Design N° 2

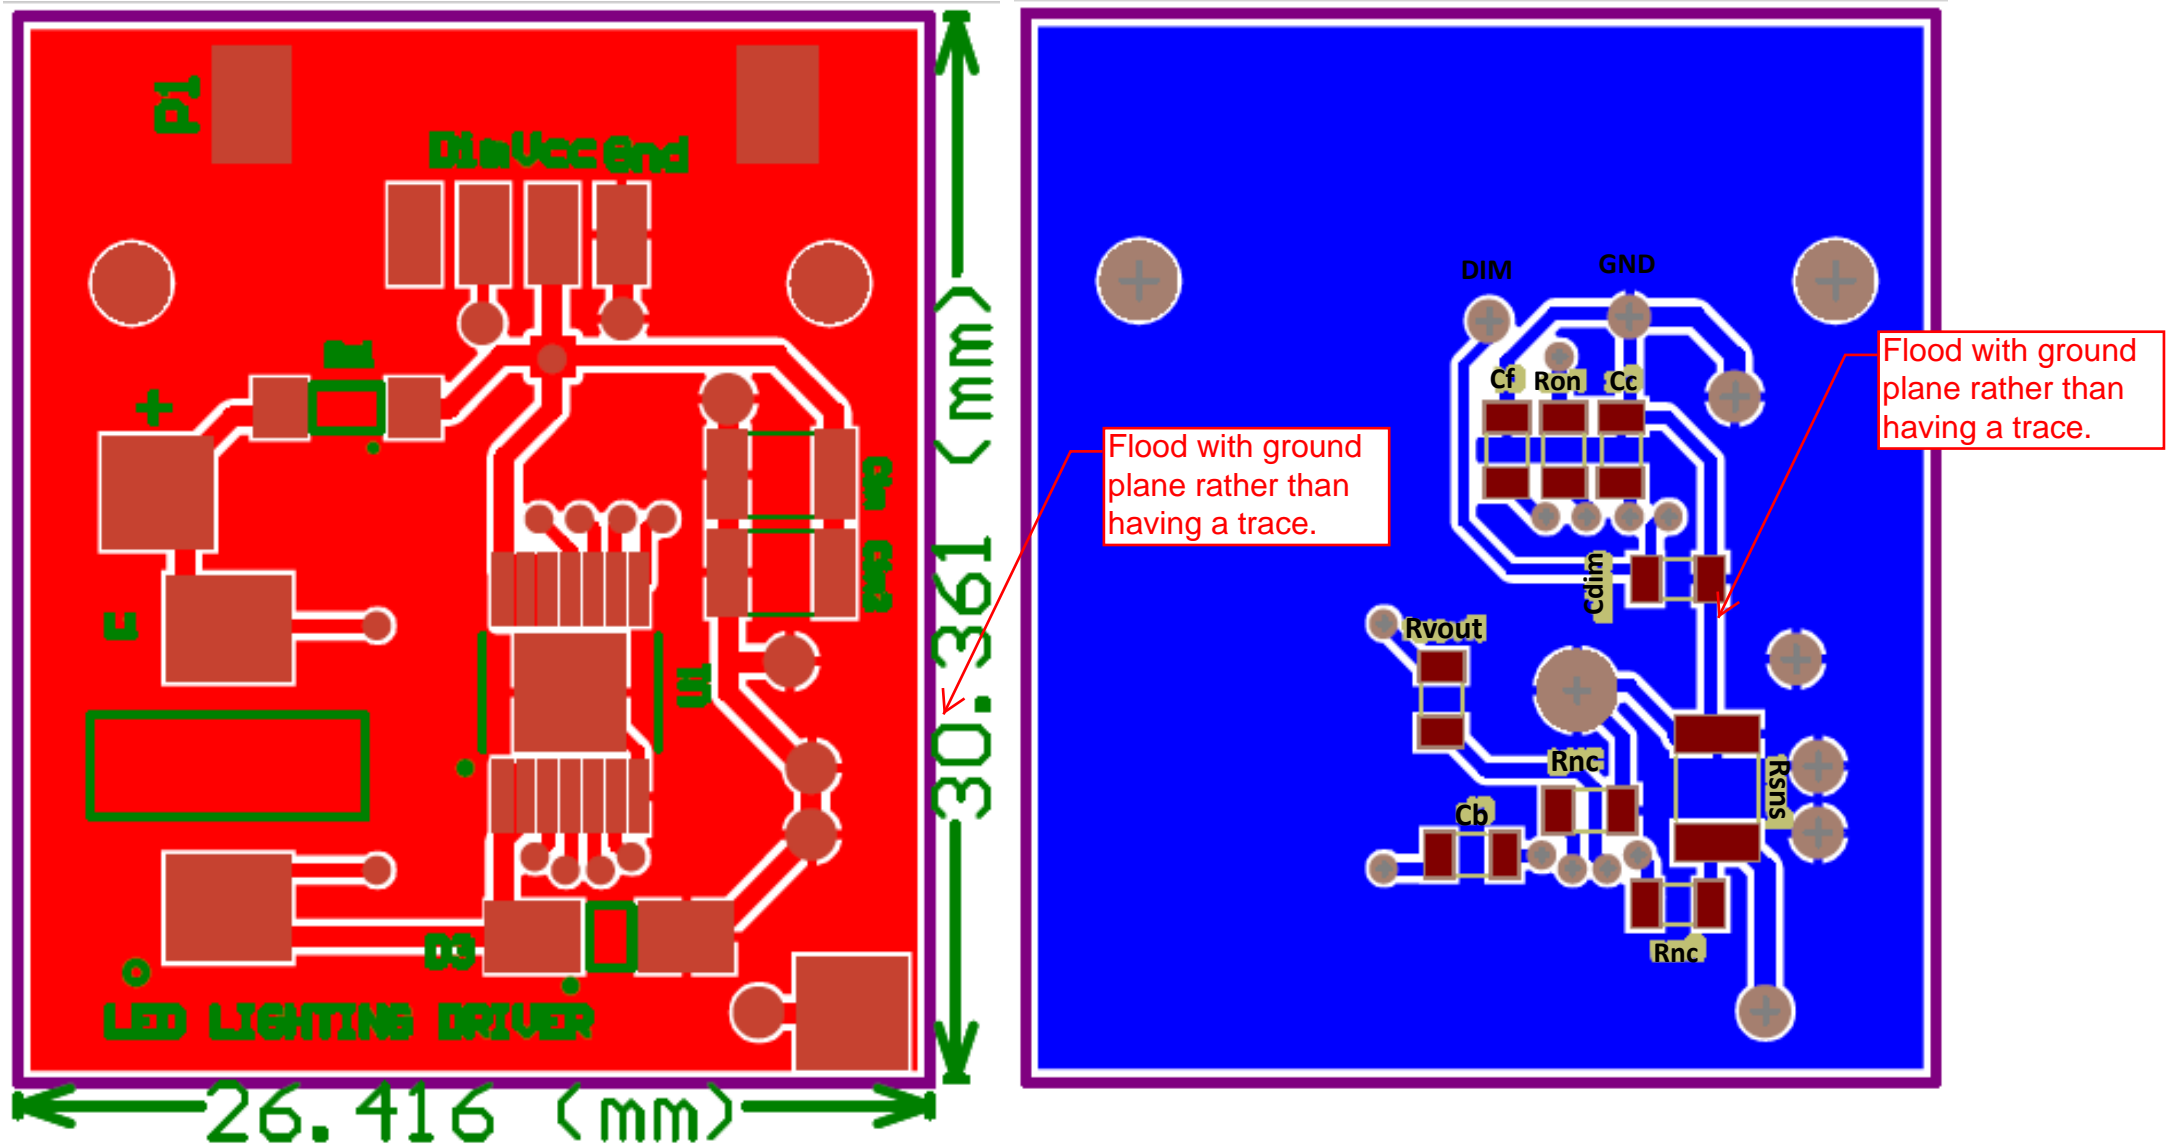
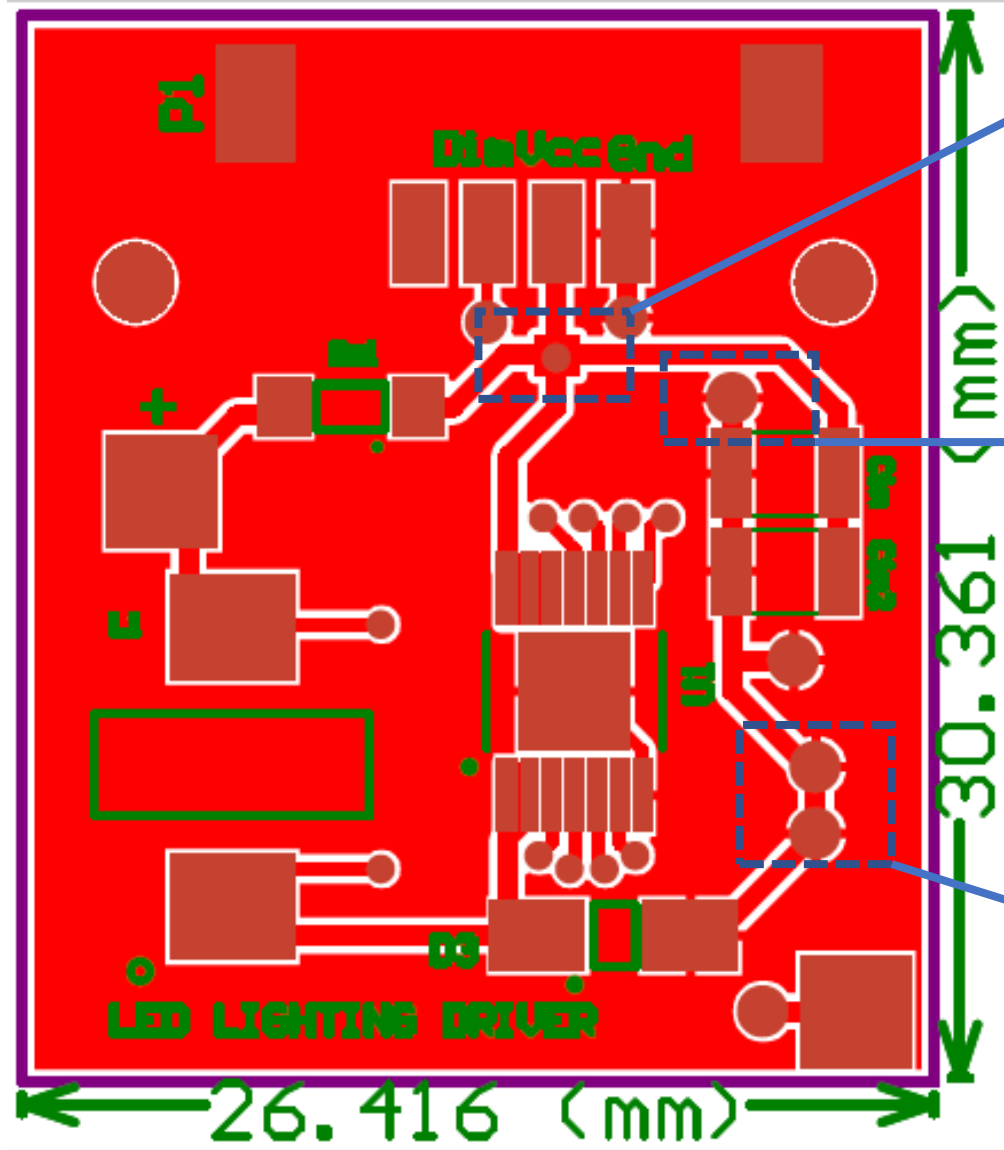
I don't know if this node is a good idea. I have read some stuff about PCB connections, but I did not find information that prohibit this. What do you think?

I put an additional via next to the capacitor with the intention to connect through a direct wire the ground pad. What do you think of this?

Is this path far enough from the other components? I notice that the connections of the vias from the top to the bottom layer are kind of thin (10 [mil] as maximum). Do you think a need to do the vias connections wider?

I don't see a big issue with this with the addition of the ground vias

That is what I was going for.

I would delete the ground paths you had initially on the top and bottom planes and just flood with ground so there is a completely unrestricted path. As it is you are still forcing a ground path in certain places. 10 mil should be ok.
